Docket Item # 16
BAR CASE #2010-0186

BAR Meeting
July 21, 2010

ISSUE: Alterations
APPLICANT: Keith A Teel & Rebecca Show
LOCATION: 414 Duke Street
ZONE: RB/Residential

The applicant is requesting approval of a Certificate of Appropriateness for replacement windows at 414 Duke Street.

Figure 1. Front facade.

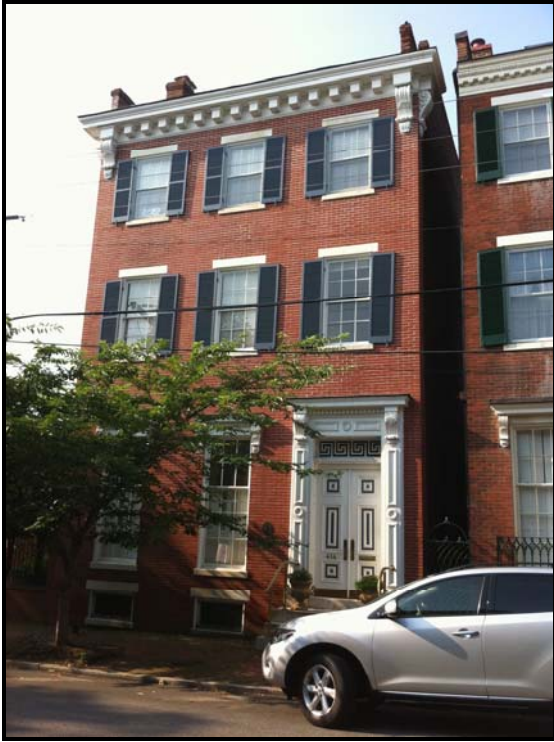
The applicant is requesting approval for replacement of 18 non-historic wood windows and 3 non-historic French doors; on the sides and rear of the home. The existing windows are single-glazed, double-hung, six-over-six, wood windows. The applicant is requesting approval of Anderson Woodwright, double hung, vinyl clad, double-glazed insert windows with 7/16" Fibrex muntins. The proposed windows will be simulated divided light with an interior spacer and an identical light pattern to the window they are replacing.

The applicant is also requesting approval of three replacement sets of French doors located on the first and second story of the east elevation. The proposed French doors are Anderson, vinyl clad, double-glazed, and simulated divided light.

Although the house dates to the middle of the 19th century, according to the applicant the existing windows on 414 Duke Street are marked with dates spanning within the last fifty years. Upon preliminary inspection from the Duke Street sidewalk and the rear alley, Staff concurs with this observation, however prior to application for a building permit Staff would like to conduct further on-site investigation of the existing windows. It is a central tenant of Historic Preservation that historic materials be maintained and repaired rather than replaced, however in this case due to the fact that the existing windows are not original, Staff does not find their replacement problematic.

Staff has no objection to replacement of the existing windows, if further investigation confirms that they are, indeed, mid 20th century replacements. However, staff cannot support vinyl clad, insert windows or the Fibrex muntins or double glazing on a house of this age.

Therefore, Staff recommends denial of the application for 18 replacement vinyl clad, double glazed, simulated divided light, Anderson replacement windows and 3 French doors and the approval of 18 single glazed, true divided, replacement windows and 3 French doors with the following conditions:

1. That the applicant use full frame replacement windows or sash replacement kits in the existing frame rather than insert or pocket replacements;
2. That the replacement windows and doors be solid wood, including the muntin bars;

3. That the windows and doors be single glazed, true divided light with the option of interior or exterior wood storms.
4. That the glazing on the glass be tint free;

5. That the dimensions of the replacement windows and doors match the existing including the rails, stiles, and muntins;
6. That the replacement window sash corners be constructed with mortise and tenon style, butt joinery rather than mitered, picture frame joinery;

7. That the replacement windows be constructed with a wood jamb liner rather than a vinyl jamb liner, or that the visual portion of the vinyl jamb be very minimal;

8. That the applicant arranges an on-site survey with Staff of all eighteen windows for replacement prior to application of a building permit.
9. That the applicant submit final window manufacturer spec sheets to staff for approval prior to application of a building permit.
